REGULAR MEETING OF THE
CITY OF CONCORD
DESIGN REVIEW BOARD

Thursday, November 12, 2015
5:30 p.m., Regular Meeting
PERMIT CENTER CONFERENCE ROOM
1950 Parkside Drive, Bldg. D

MEMORANDUM

SHEET TITLE: PROJECT ELEVATION

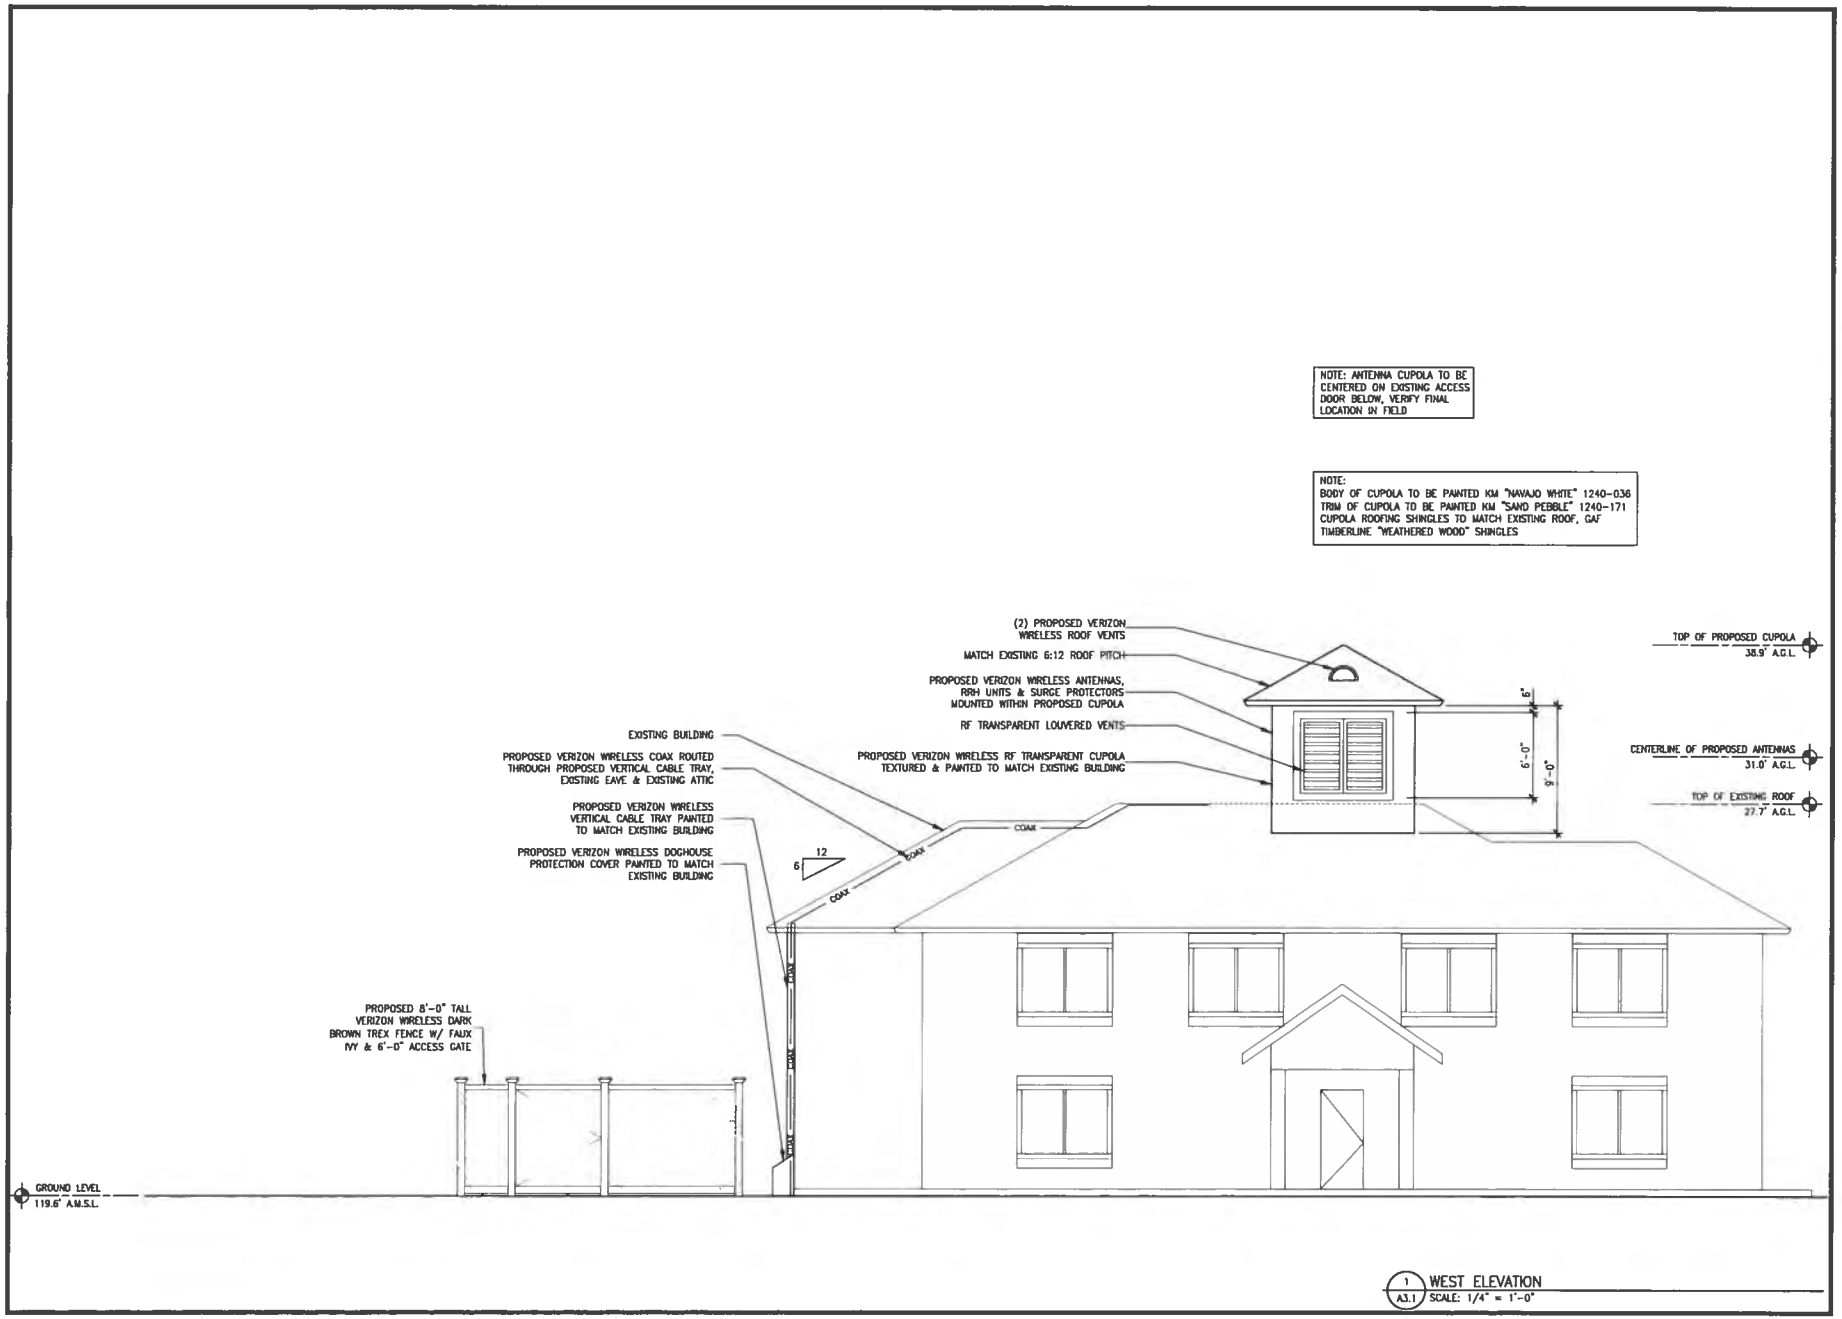
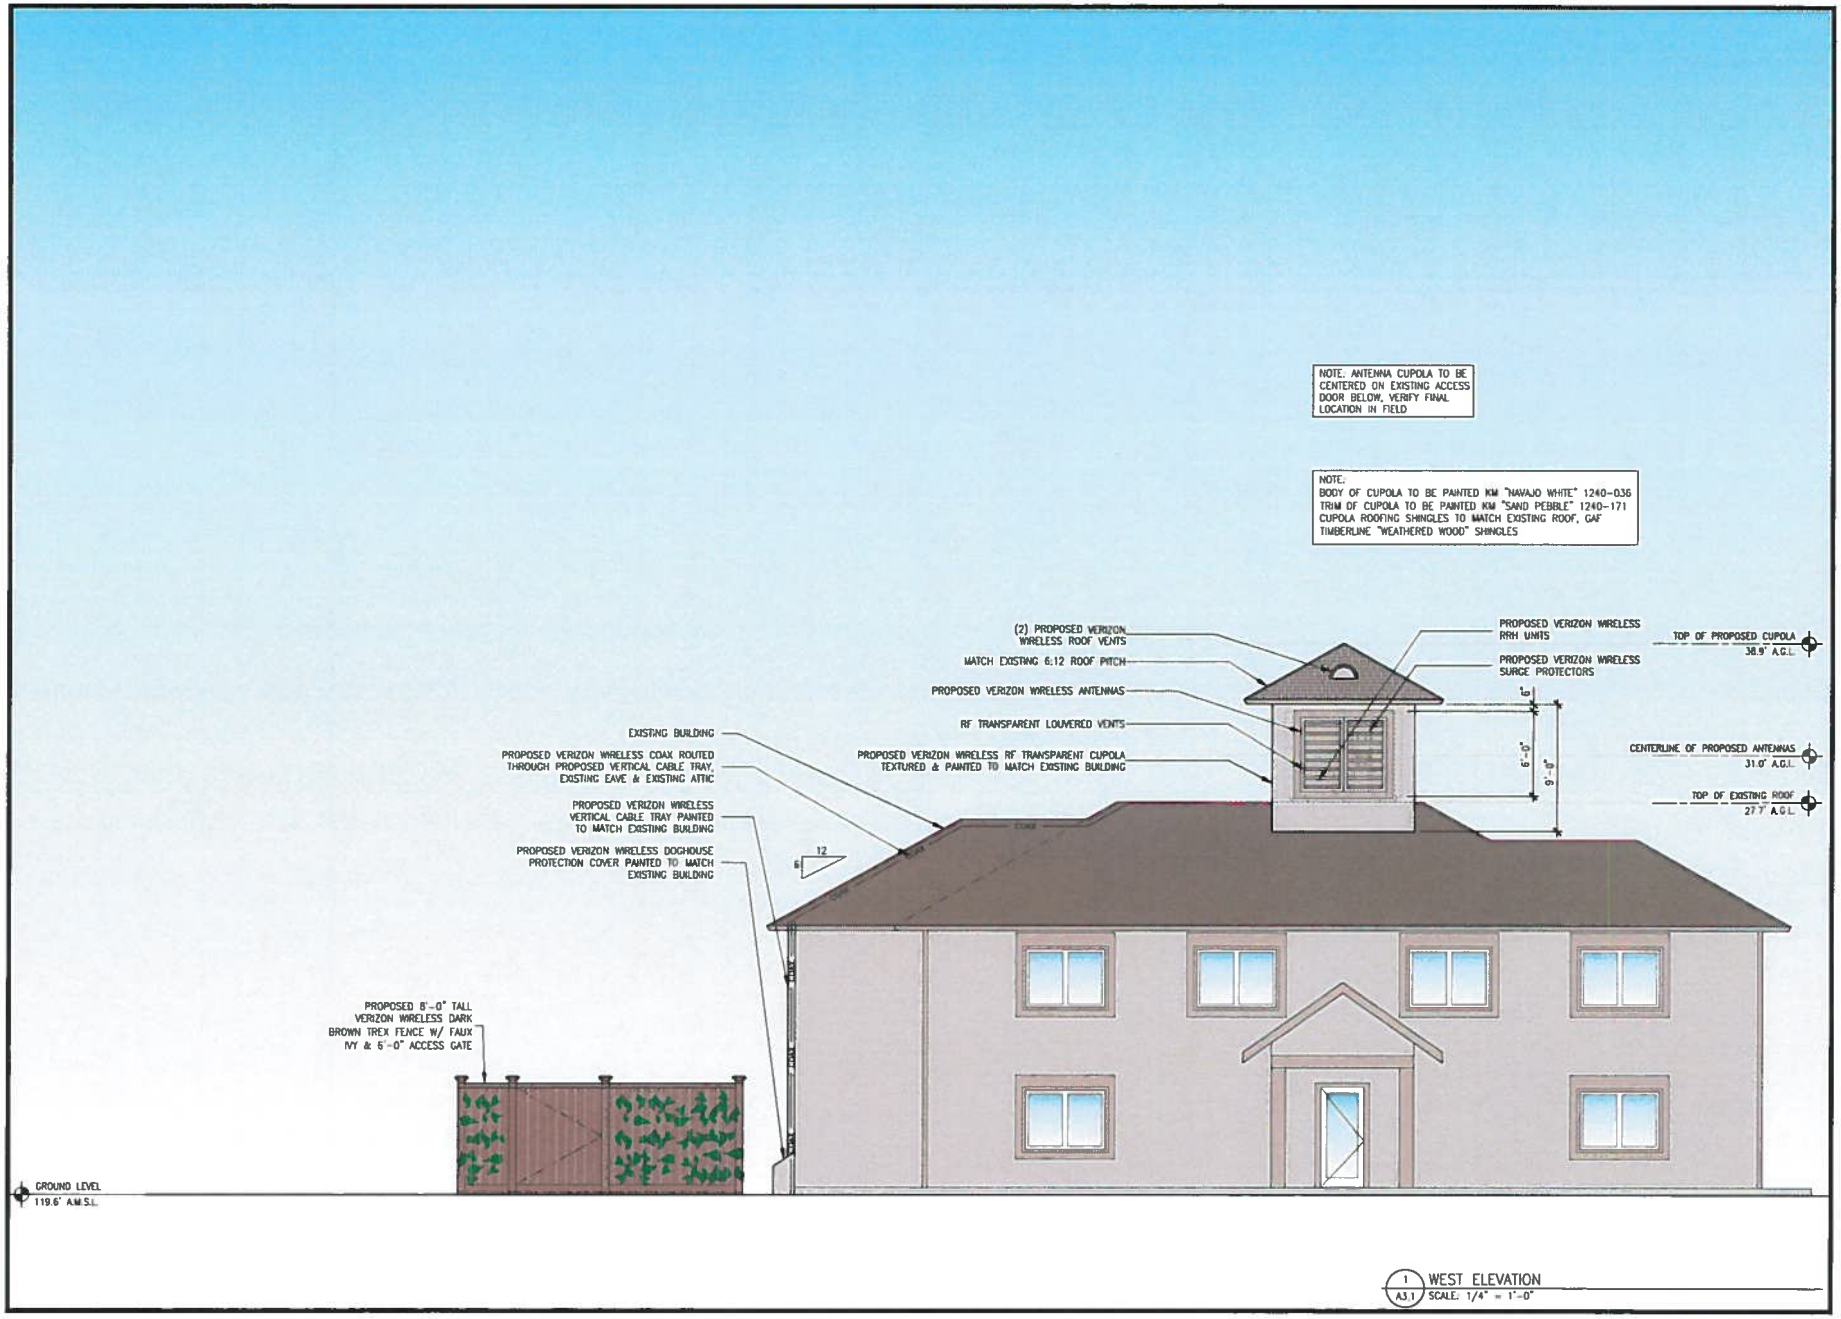
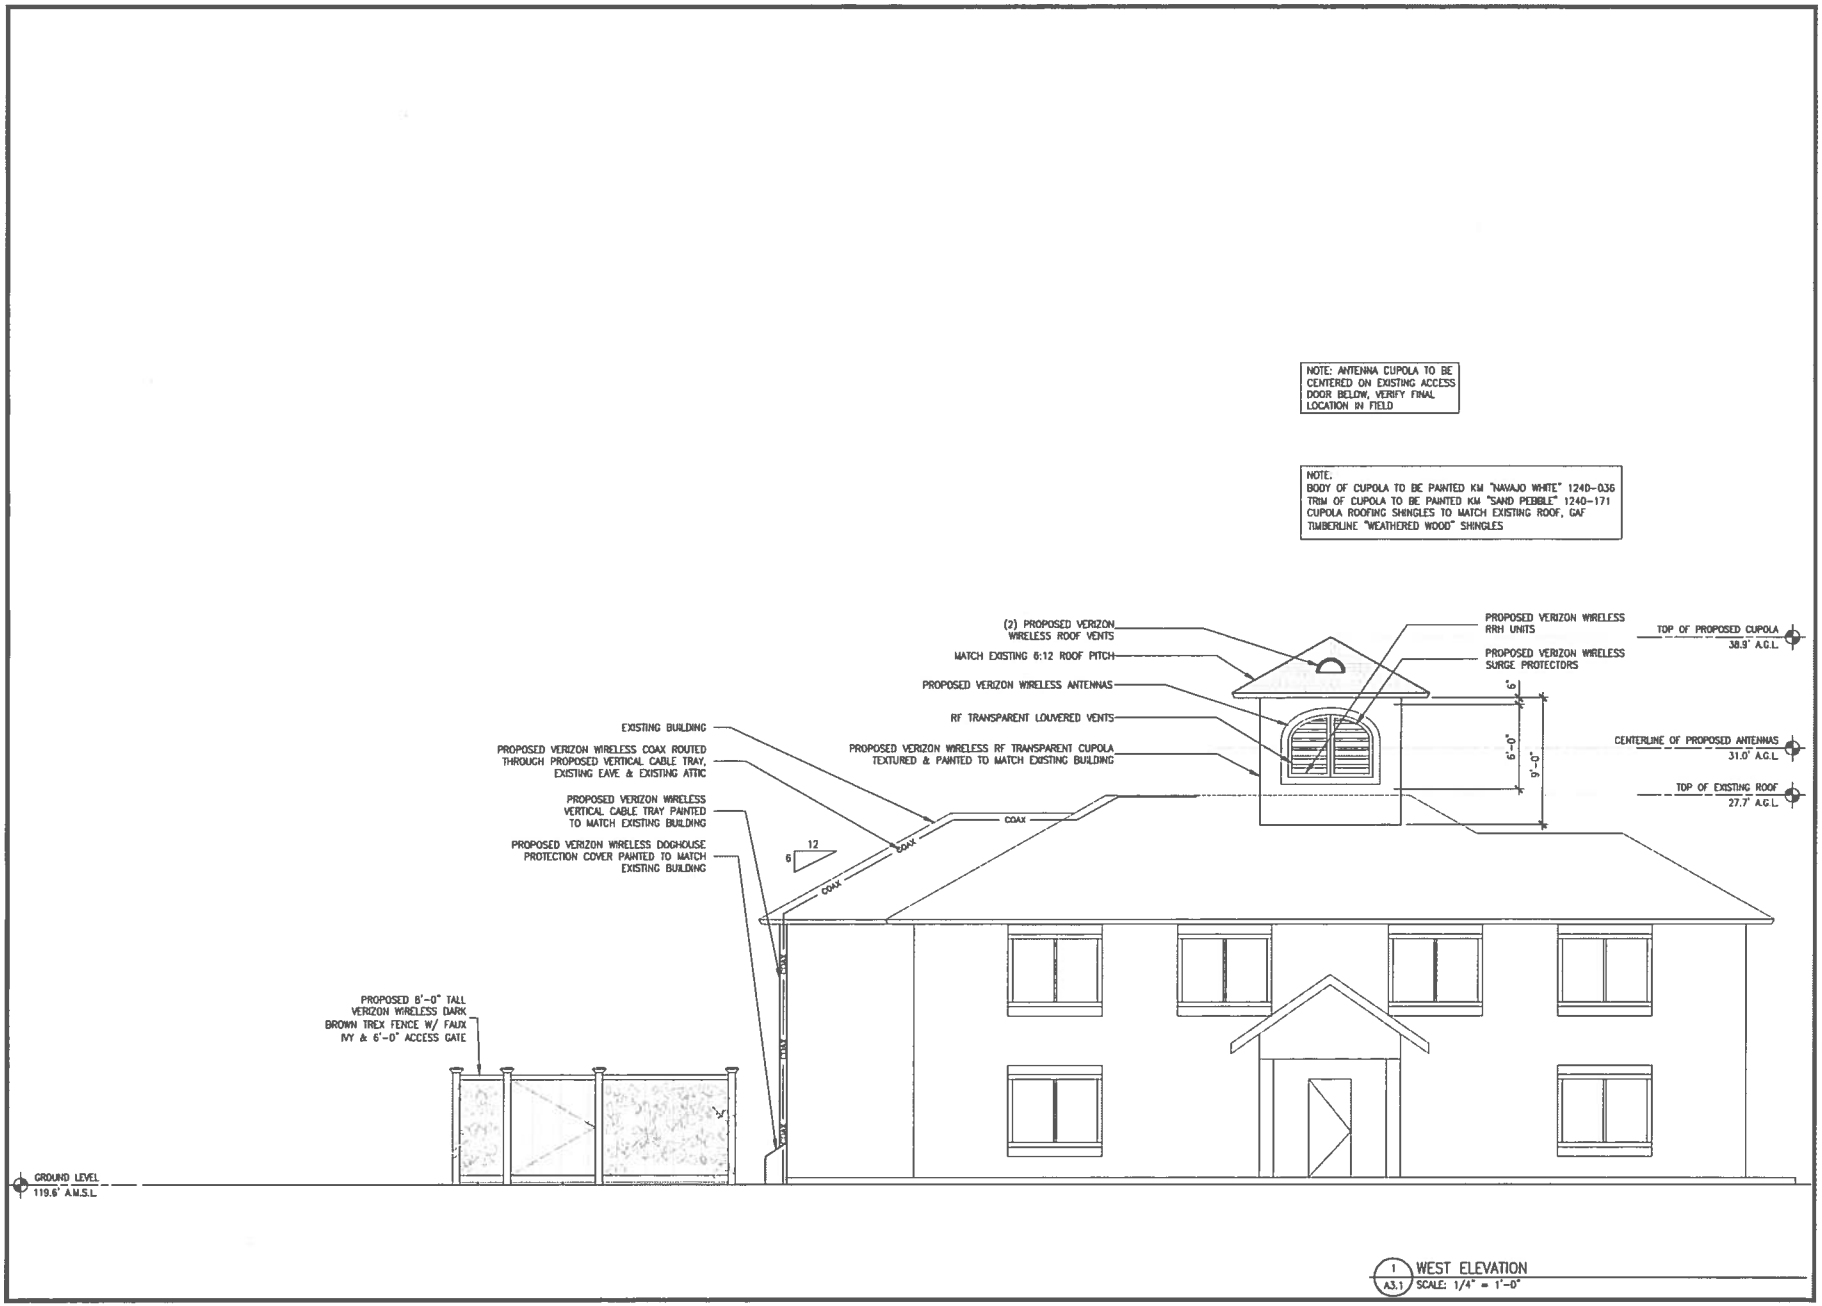
- Preference towards the squared louver design as it is consistent with the existing architecture.
- Add a base to the cupola design or trim to the base of the cupola.
- Preference towards landscaping with live plant material such as a trellis.
